FED. ROAD DIST. NO.	STATE	FED. AID PROJ. NO.	FISCAL YEAR	SHEET NO.	TOTAL SHEETS
HAWAII	HAW.		1978	86	159

PROJECT NO. 93B-01-75

UTILITIES

SHEET No. 3 OF 17 SHEETS C.O. 88

ADJUSTING 6" WATER LINE

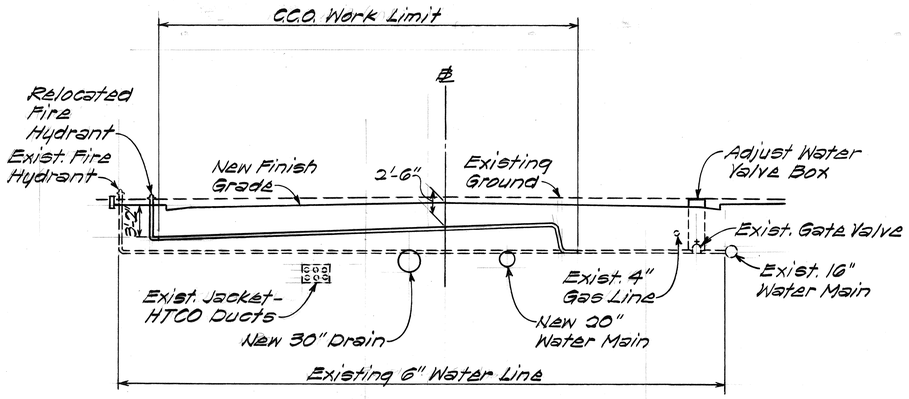
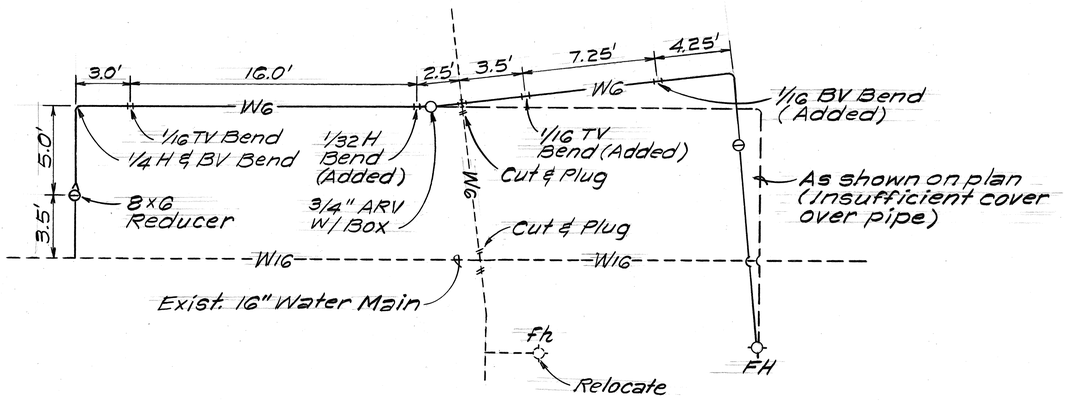
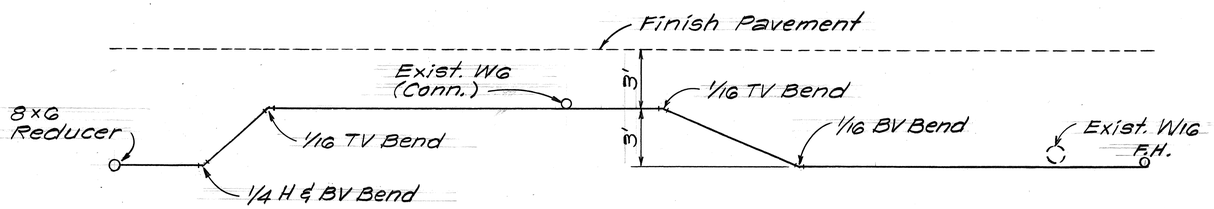
(CCO #4) See Plan Sht. No. 90S-1 for Adjustments

(CCO #14)
Adjust 6-Inch Water Line Sta. 10+22. See Plan Sht. No. 90S-1 for Adjustments.

CCO #4
FOR ADJUSTING 6-INCH WATER LINE SEE PLAN SHT. NO. 205-1. (ALSO SEE SHTS. 72 & 86)

℄ STA. 12+25 ±
C.C.O. #4
Not to Scale

LOWERING EXIST. 8" WATER LINE

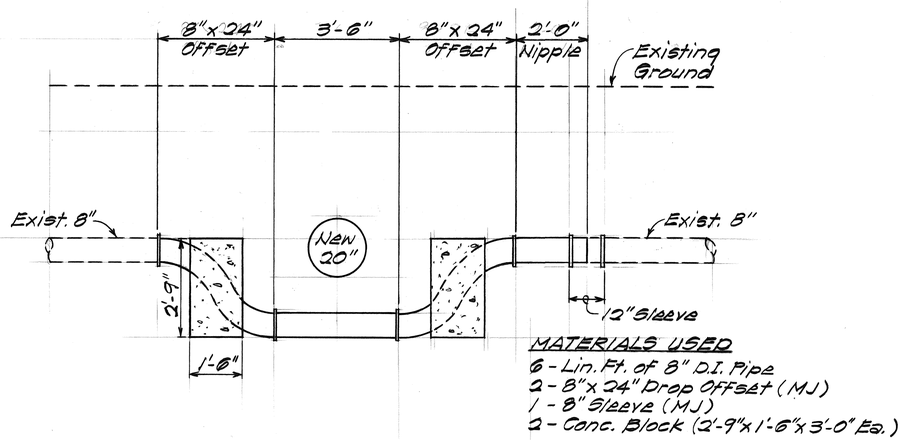
MATERIALS USED
6 - Lin. Ft. of 8" D.I. Pipe
2 - 8"x 24" Drop Offset (MJ)
1 - 8" Sleeve (MJ)
2 - Conc. Block (2'-9"x 1'-6"x 3'-0" Ea.)

STA. 0+00
C.C.O. #20
Scale: 1/2" = 1'-0"

FED. ROAD DIST. NO.	STATE	FED. AID PROJ. NO.	FISCAL YEAR	SHEET NO.	TOTAL SHEETS
HAWAII	HAW.	93B-01-75, UNIT I	1983	96S-1	159

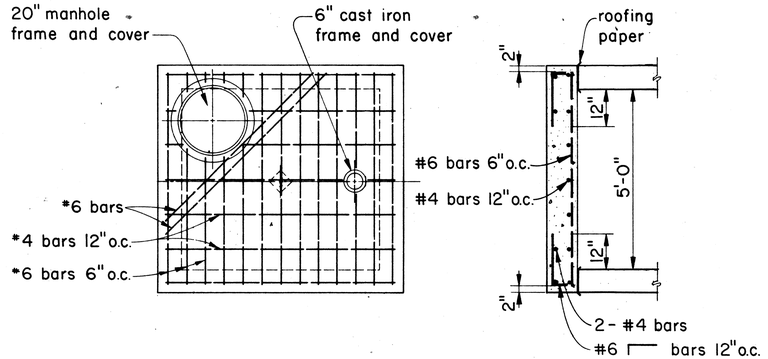
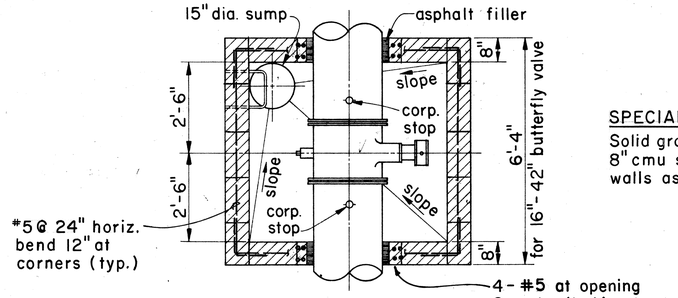
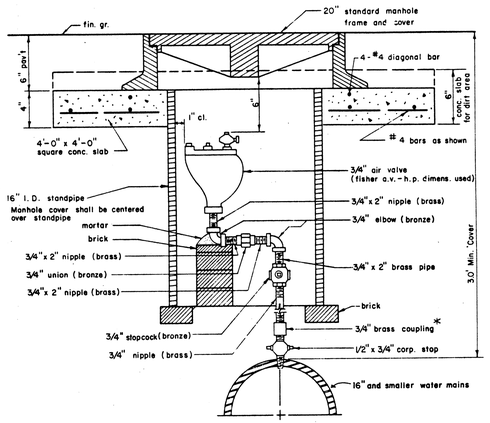
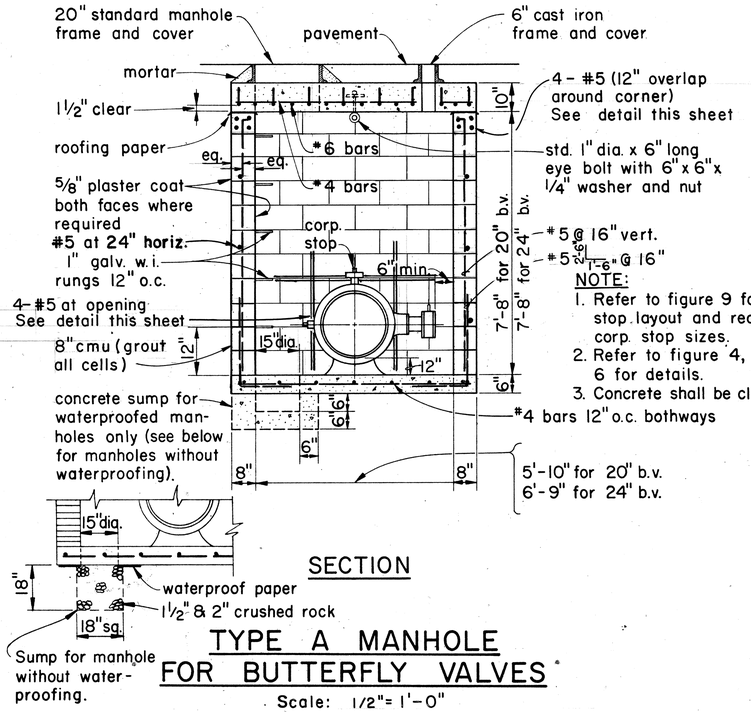
CCO # 25
Sta. 32+65 ± o/s 25' ± Left.
Demolish Existing Type C Air Valve Manhole. Construct in its place an Air Relief Valve Box in accordance with BWS Standard Details. See Plan Sht. No. 96 S-1.
Existing 20-Inch Cast Iron Frame and Cover shall be removed, cleaned, painted and reinstalled.

CCO #10
CONSTRUCT MH IN FARRINGTON HWY ACCORDANCE WITH BWS STANDARD DE-TAILS REVISED. SEE PLAN SHT. NO. 206-1 FOR DETAILS.

CCO #10
Construct MH in accordance with BWS Standard Details Revised. See Plan Sht. No. 96 S-1.

CCO# 10
Construct MH in accordance with BWS Standard Details Revised. See Plan Sht. No. 96 B-1.

CCO # 10
CONST. MH IN ACCORDANCE W/BWS ST'D DET. REV. SEE PLAN SHT. NO. 96 S-1.

CCO # 10
Construct MH in accordance BWS Standard Details Revised. See Plan Sht. No. 96 S-1.

CCO # 10
CONSTRUCT MH IN ACCORDANCE WITH BWS STANDARD DETAILS REVISED. SEE PLAN SHT. NO. 96-5-1.

SPECIAL NOTE:
Solid grouted and reinforced 8" cmu substituted for 8" brick walls as shown.

LOWERING OF SMH AT STA. 20+87
(CCO # 24)

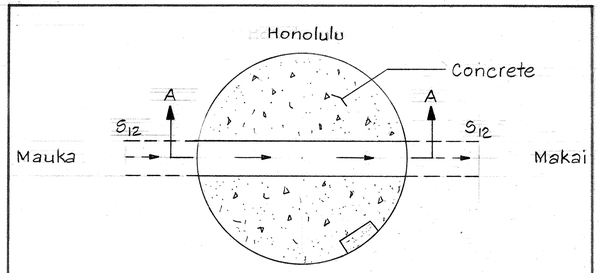
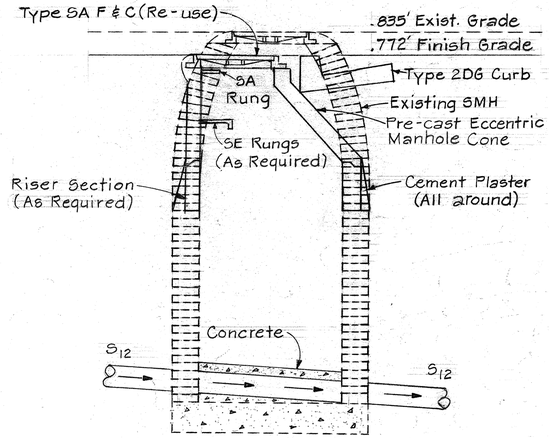
Sta. 20+80
Lower Top of Existing S.M.H. and install (1) Pre-Cast Eccentric Manhole Cone and Riser Section as required. See Plan Sht. No. 92 for details.
CCO #24

Sta. 20+80
Lower Top of Existing S.M.H. and install (1) Pre-Cast Eccentric Manhole Cone and Riser Section as required. See Plan Sht. No. 92 for details.
CCO #24
